PLANNING COMMISSION REPORT
Regular Agenda -Public Hearing Item

PC Staff Report
9/23/13

ITEM NO. 8B: PRELIMINARY DEVELOPMENT PLAN FOR 9 DEL LOFTS; 900 DELAWARE ST (MKM)

PDP-13-00299: Consider a Preliminary Development Plan and associated modifications for 9 Del Lofts, a multi-dwelling residential development with 43 dwelling units, located at 900 Delaware St. Modification requests are related to the off-street parking requirements, and setback standards. Submitted by Bartlett & West Inc. for Provident Family, LP, property owner of record.

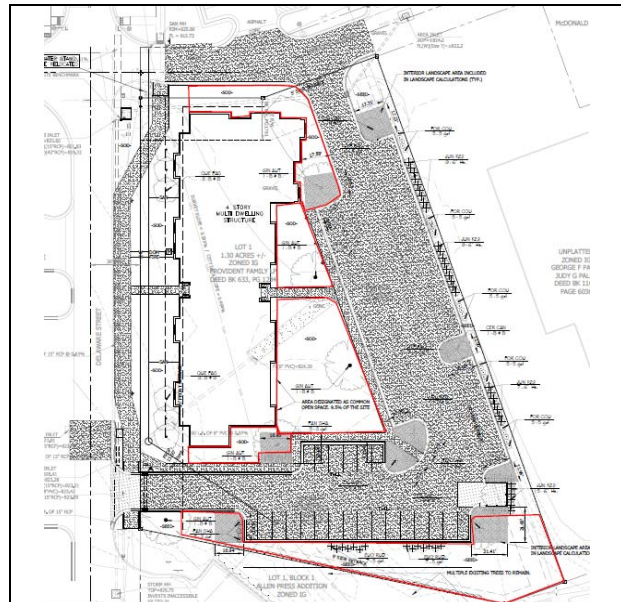
Section 20-701(j) notes that 20% of the site must be located within common open space. The plan does not note at this time the amount of area that is within the common open space. This should be noted on the plan to insure that the area requirement is met.

Staff Finding – The applicant provided a graphic which showed the proposed common open space with the area. (Figure 3) As shown in the graphic, the common open space makes up approximately 25% of the site. The plan must be revised to delineate the area which is to be considered 'common open space' and note the percentage of the site this is located within the common open space.

- b. Delineate the common open space on the plan and note the percentage of the site which is included. Minimum of 20% of the site is required.
 - c. Revise PDP Plan Note No. 14 to list the modification being requested from the required off-street parking and to refer to the change requested to the setback as a 'modification'.
